PATRICK J. CONTE, M.D.
11 Evergreen Place
Roseland, New Jersey 07068

August 26, 1985

Control Number: 104071

Deficiencies on license application from Canfield Radiology Ass.

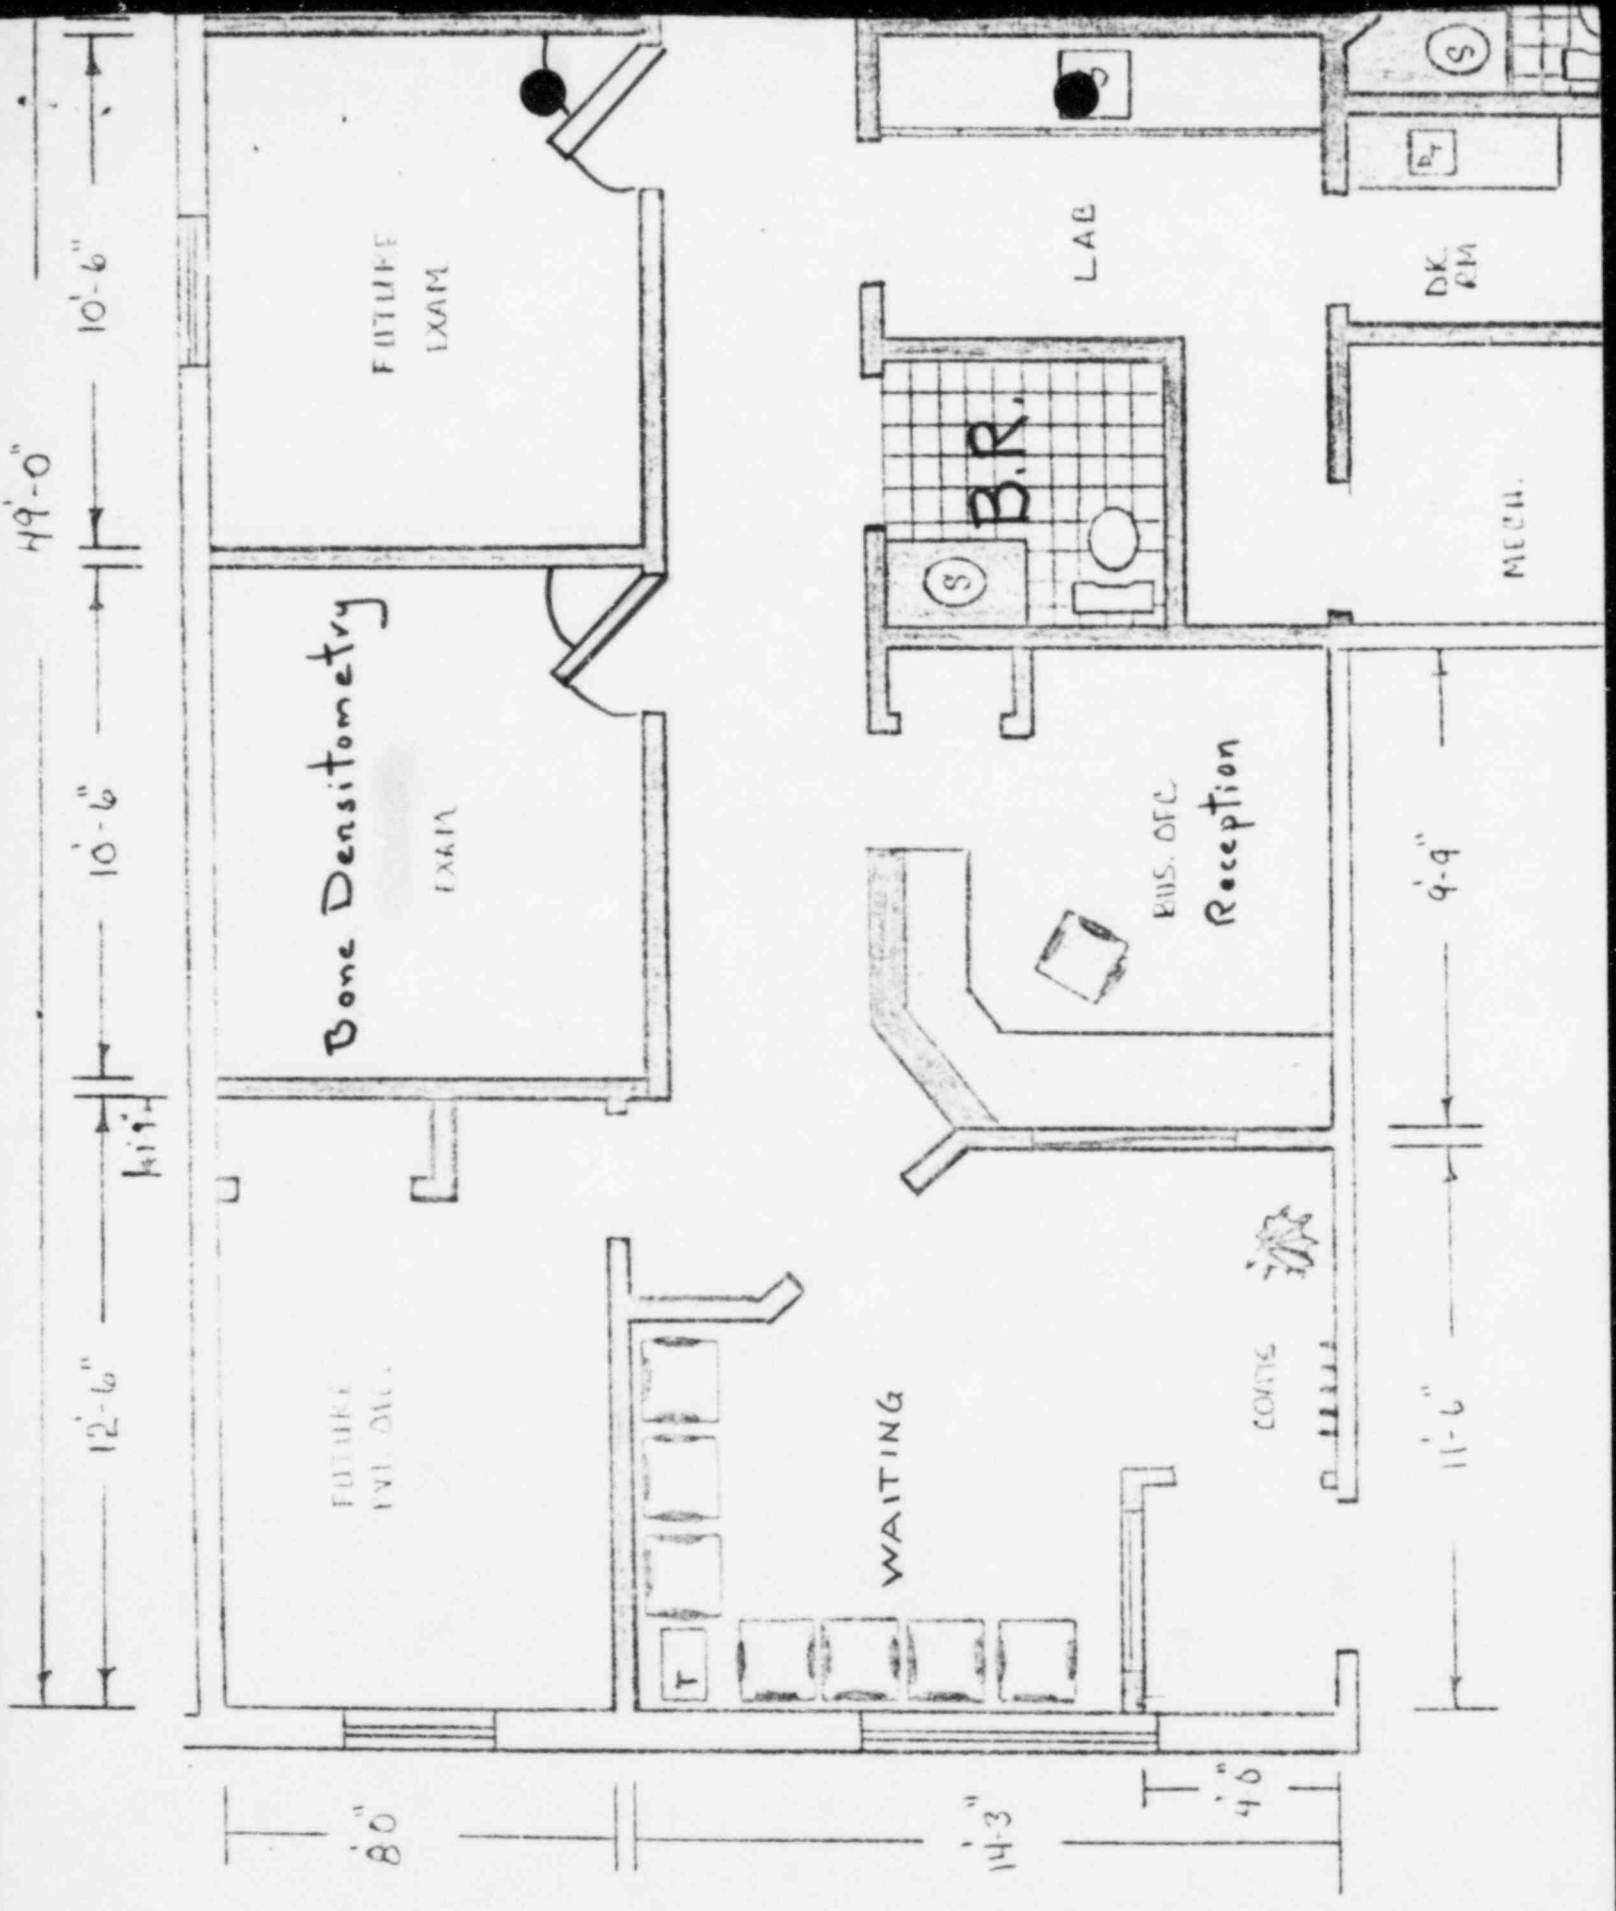
(2) Facility diagram not sent

1. No survey instruments shall be used at this facility. The licensee, however, shall have one available for use.
2. A facility diagram is attached.
3. Employee Training shall include instructions as outlined in Title 10 CFR, Parts 19 and 20; specific conditions of the materials license; radiation safety instructions as described in Regulatory Guide 10.8; and specific operating procedures for the bone densitometry system. Emergency procedures shall also be included.
